### APPEAL SUMMARY

<b>Appeal ID:</b> 27664	<b>Project Address:</b> 1616 NW Northrup St
<b>Hearing Date:</b> 4/13/22	<b>Appellant Name:</b> Eli Metcalf
<b>Case No.:</b> B-004	<b>Appellant Phone:</b> 9716782531
<b>Appeal Type:</b> Building	<b>Plans Examiner/Inspector:</b> Steven Freeh
<b>Project Type:</b> commercial	<b>Stories:</b> 3 <b>Occupancy:</b> R-3 <b>Construction Type:</b> V-B
<b>Building/Business Name:</b>	<b>Fire Sprinklers:</b> Yes - NFPA 13D throughout
<b>Appeal Involves:</b> Reconsideration of appeal, other: Change of use from residential duplex to (2) residential transient living units with less than 10 occupants each (Unit A = 5occ, Unit B = 9occ).	
<b>LUR or Permit Application No.:</b> 22-103397-CO	
<b>Plan Submitted Option:</b> pdf [File 1]	<b>Proposed use:</b> Residence –Transient Living (R3)

#### Appeal item 1

GROUND FLOOR PLAN (UNIT A)

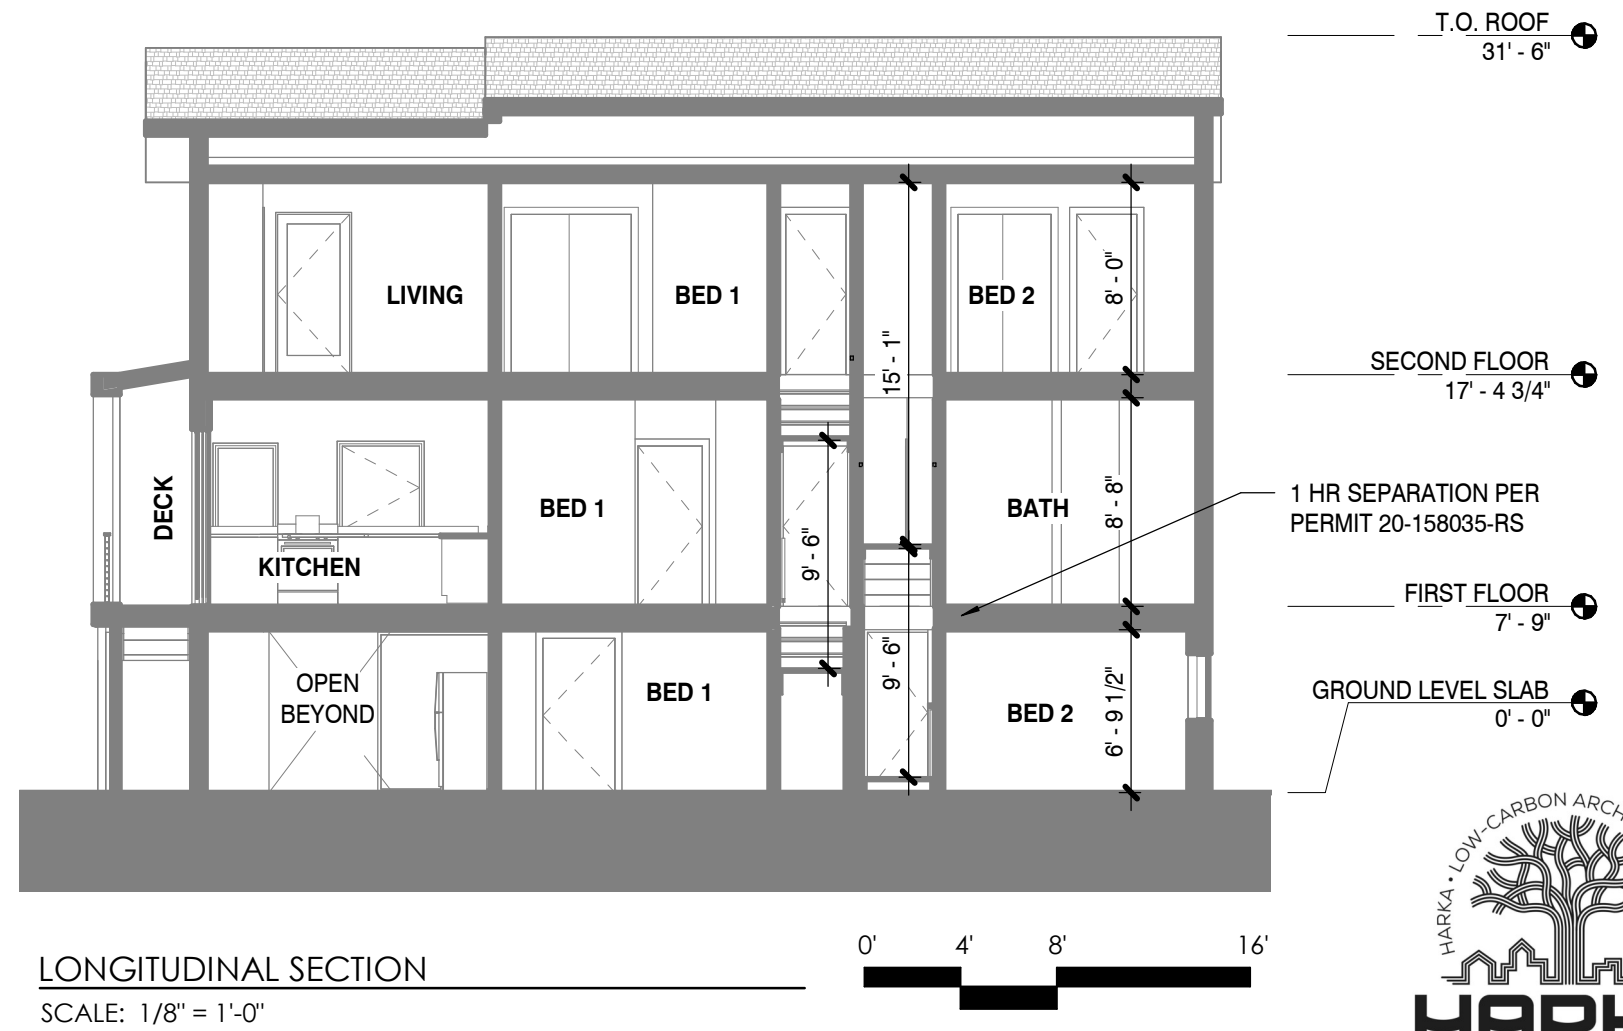
<b>Code Section</b>	1207.2
<b>Requires</b>	Occupiable spaces, habitable spaces and corridors shall have a ceiling height of not less than 7'-6" above the finished floor. Bathrooms, toilet rooms, kitchens, storage rooms and laundry rooms shall have a ceiling height of not less than 7 feet above the finished floor.
<b>Code Modification or Alternate Requested</b>	Requesting lower than 7'-6" ceilings in the basement unit.
<b>Proposed Design</b>	We propose a 6'-9.5" ceiling with 6'4" ceiling at some locations under HVAC ducts.
<b>Reason for alternative</b>	Since a 6'-8" ceiling height is permitted in the Portland code guide for residential basements, we believe that the use of these units matches the intention of the residential ceiling height requirement, rather than the 7'-6" commercial requirement. These are single family dwelling units, intended to be rented to a single group (no more than 5-6 people). The occupancy is R3 and hazard is nearly identical to its currently R3 use. Excavating the basement slab to add 8.5" represents an unreasonable burden. The HVAC ducts remain above the minimum door height and can be considered a pass through area. The ducts do not obstruct the livable area, only the hallway and portions of the entry space to the living room and bathroom.

**Reduction in minimum required headroom in basement unit from 7 feet 6 inches to 6' 9.5 inches and 6 feet 4 inches below HVAC ducts: Denied. Proposal does not provide equivalent Life Safety protection.**
